Municipality of Anchorage

Building Safety Division

RE: Stop Work Orders: Lot 7A Seaview Heights Subdivision; Permit 00-6083
Lot 7A Seaview Heights Subdivision; Permit 01-0076

Fill & Grade

Restriction of a Drainage Path

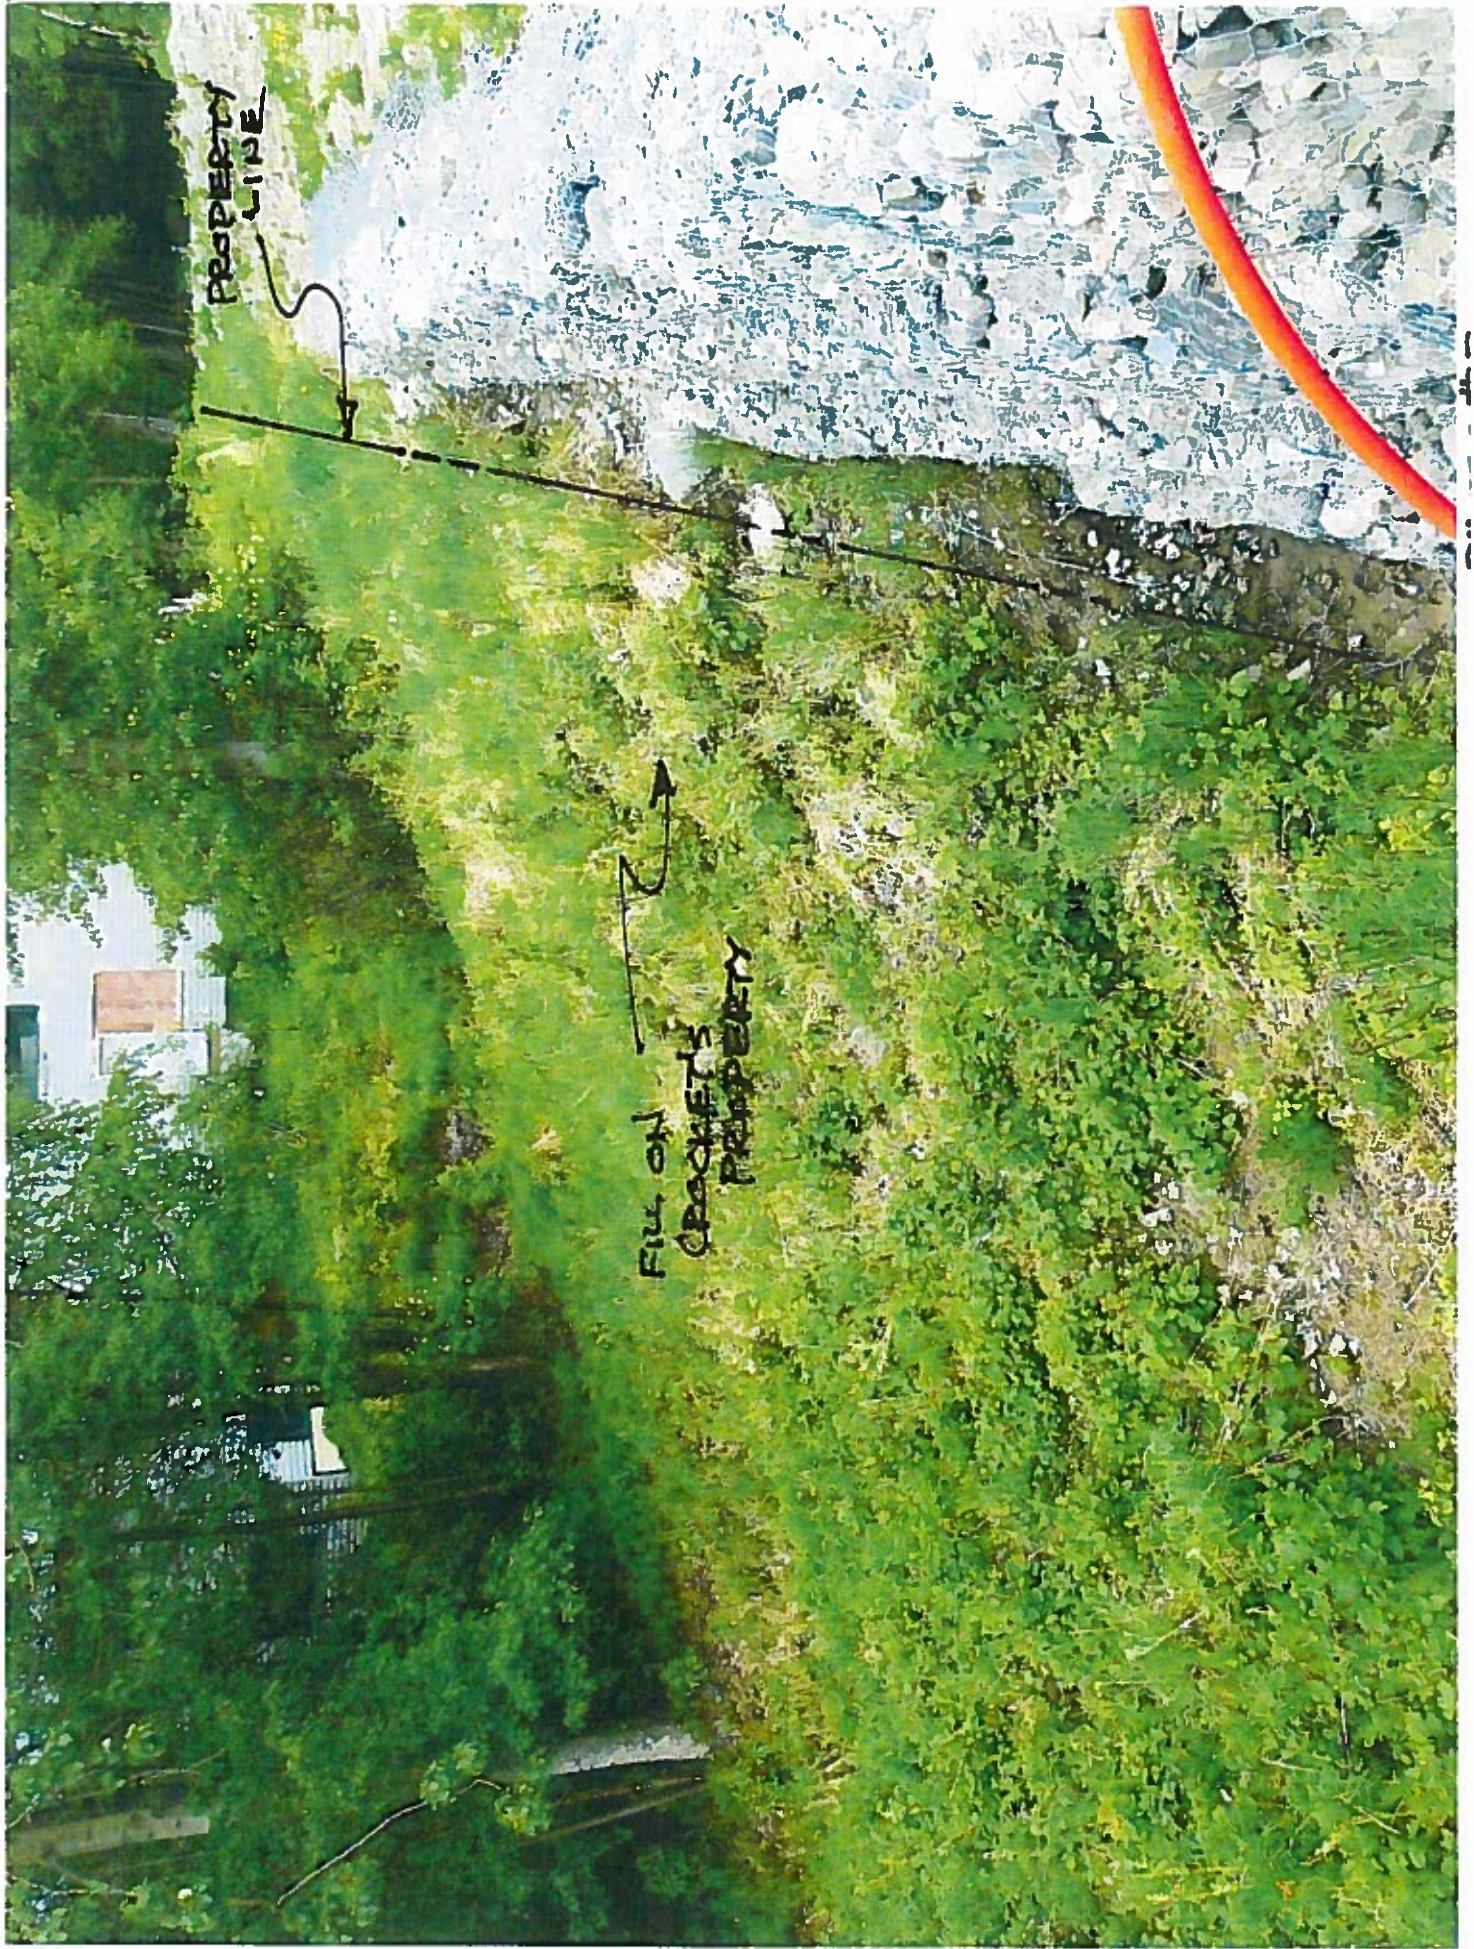
The drainage path from Lot 8 to Lot 7B has been impeded by the construction of Lori Drive. No culvert was placed.

PAOTO #4

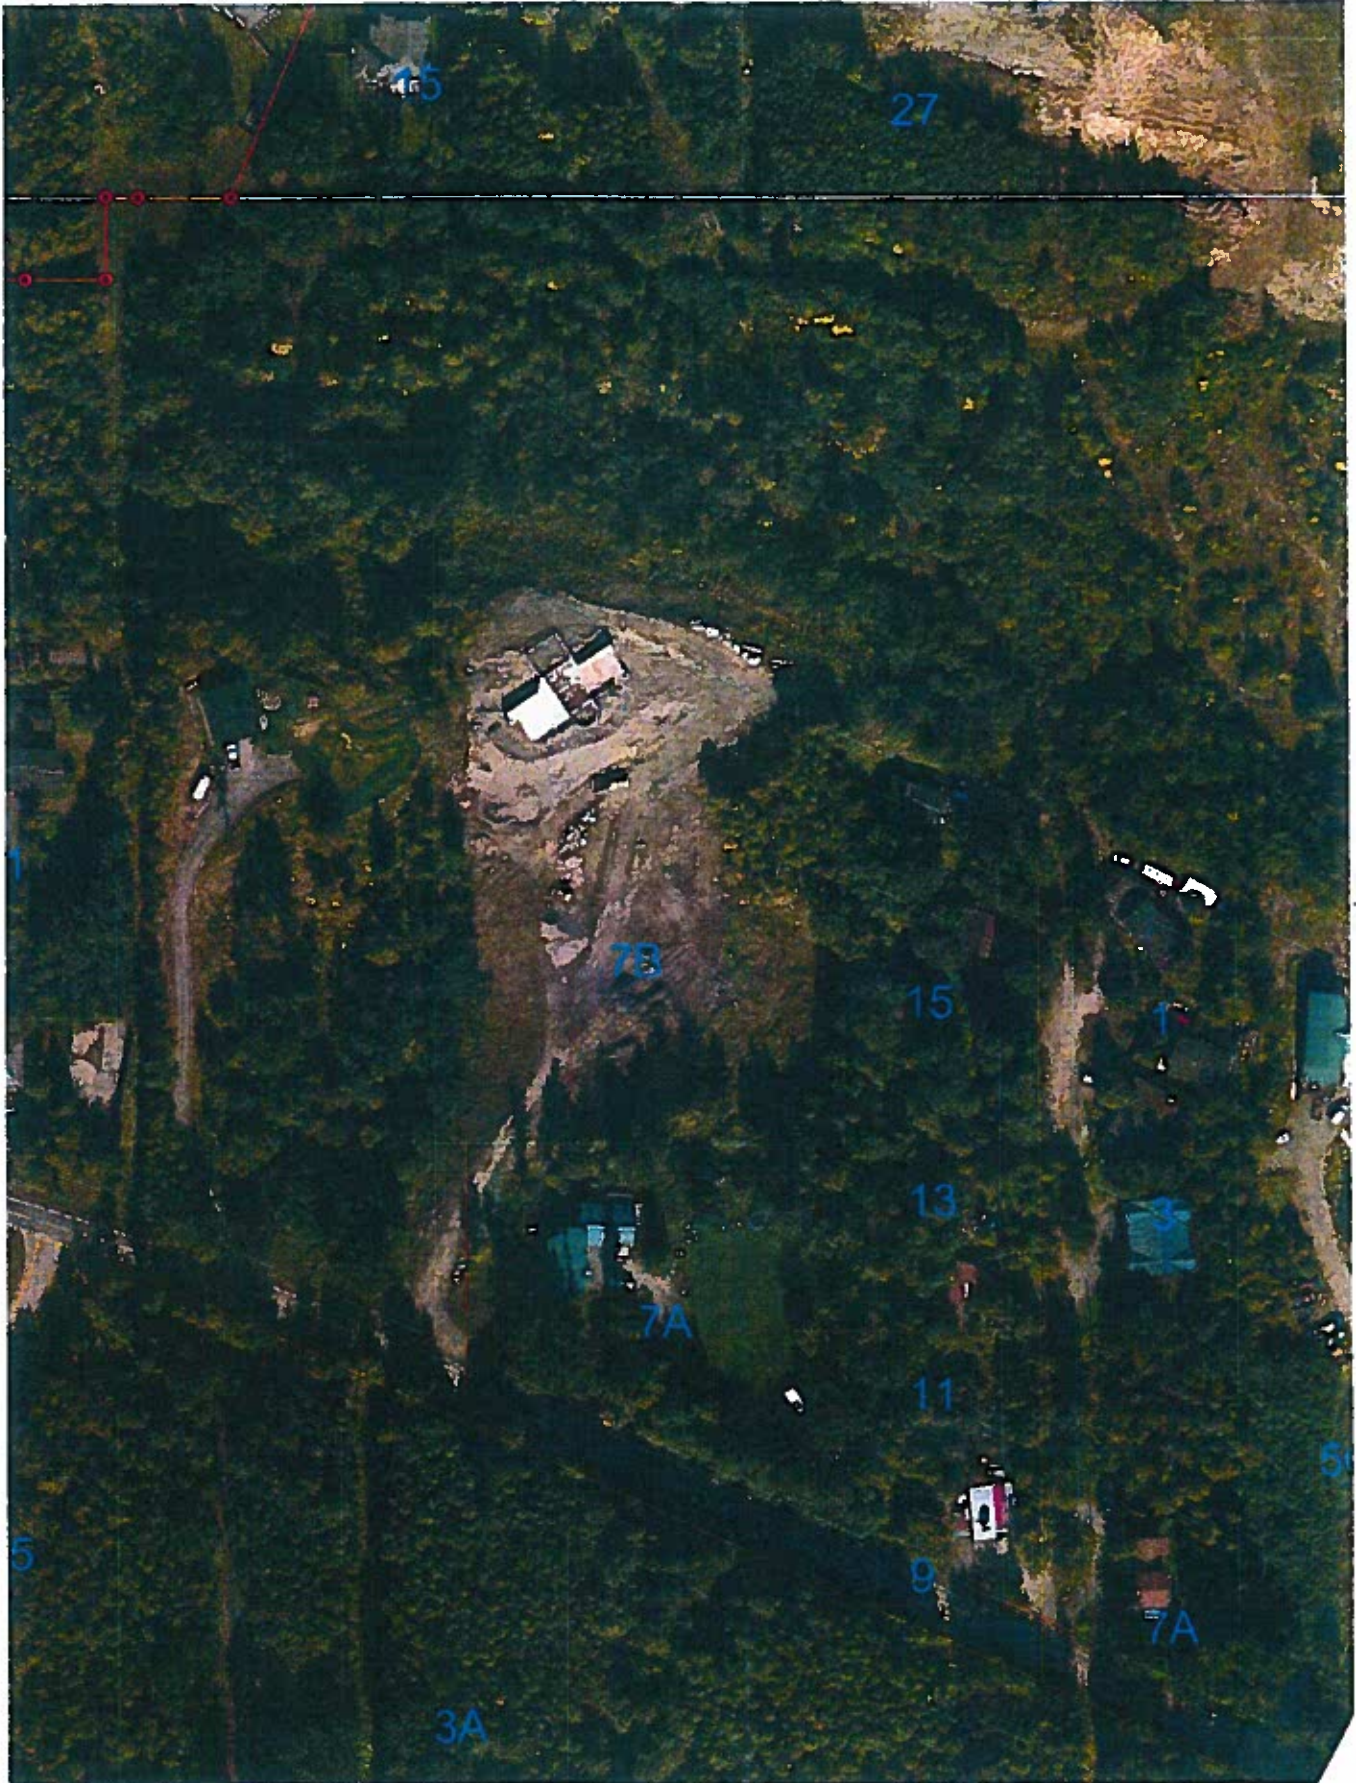
PROPERTY LINE

FILL ON
CROCKET'S
PROPERTY
